Seagate Technology

Subject: Slow DT Timing Revision Proposal for SPI-3

DT SETUP AND HOLD TIMINGS FOR DT DATA TRANSFER

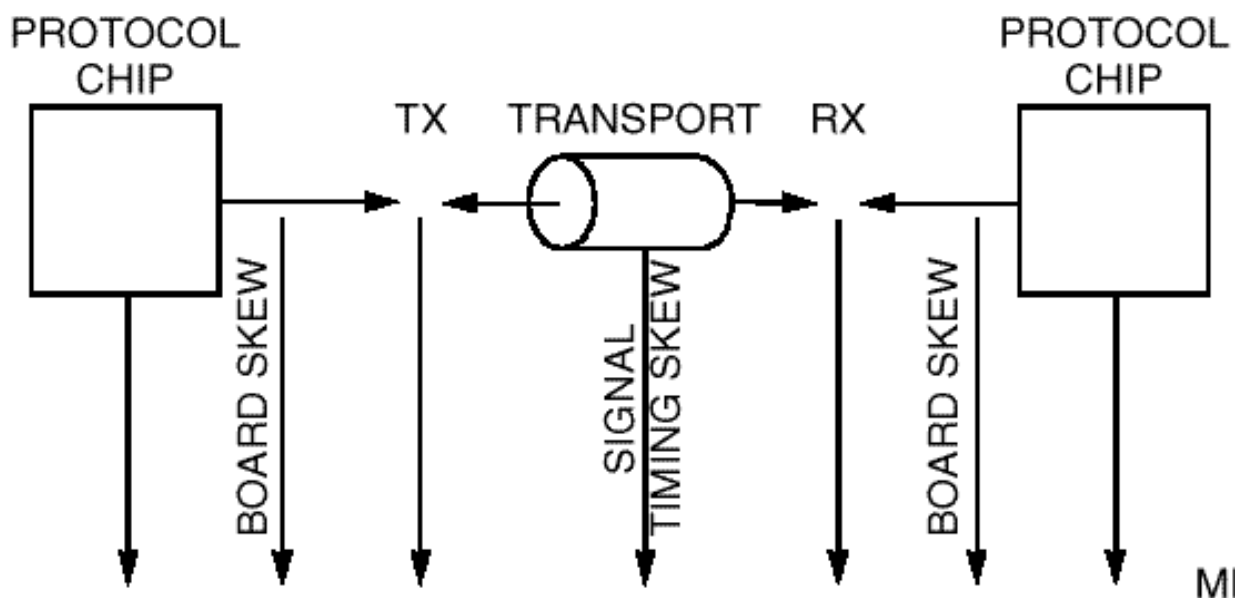
The analysis and the working group discussions concluded that the slower DT timing would work but the specifications were inconsistent with the Fast 80 methodology and should be revised to be more consistent with this methodology. The present SPI-3 slower DT timing is adopted from Single Transition (ST) timing while the last presentation I made and the working group conclusion was to start with the Fast 80 specifications and double the allotments as the transfer rate is halved. The bulk of the working group concluded the printed circuit allocation should be constant but an influential member of the working group requested that the printed circuit allocation be increased with the lower transfer rates. I have decided in the attached proposal to accommodate the influential member. Finally the last working group agreed that the analysis should be converted to a proposal.

The ATN and CRC receive times have been adjusted for the slow categories to account for the above revision of the Signal Skew Timing values.

Based upon the working group conclusions I have generated the following proposed replacements in SPI-3. Revision 1 includes the changes recommended in the 5/2/99 WG.

Timing Mode _____ Minimum

Fast 80

(6,25 IDEAL) 5,0 _ 0,2 _____ 4,8 _____ 3,35 _____ 1,45 _ 0,2 _ 1,25 _ Setup

(6,25 IDEAL) 5,0 _ 0,2 _____ 4,8 _____ 3,35 _____ 1,45 _ 0,2 _ 1,25 _ Hold

Fast 40

(12,5 IDEAL) 10,0_ 0,4 _____ 9,6 _____ 6,7 _____ 2,9 ____ 0,4 _ 2,5 _ Setup

(12,5 IDEAL) 10,0_ 0,4 _____ 9,6 _____ 6,7 _____ 2,9 ____ 0,4 _ 2,5 _ Hold

Fast 20

(25 IDEAL) _ 20,0_ 0,8 _____ 19,2 _____ 13,4 _____ 5,8 ____ 0,8 _ 5,0 _ Setup

(25 IDEAL) _ 20,0_ 0,8 _____ 19,2 _____ 13,4 _____ 5,8 ____ 0,8 _ 5,0 _ Hold

Fast 10

(50 IDEAL) _ 40,0_ 1,6 _____ 38,4 _____ 26,8 _____ 11,6 ____ 1,6 _ 10,0 _ Setup

(50 IDEAL) _ 40,0_ 1,6 _____ 38,4 _____ 26,8 _____ 11,6 ____ 1,6 _ 10,0 _ Hold
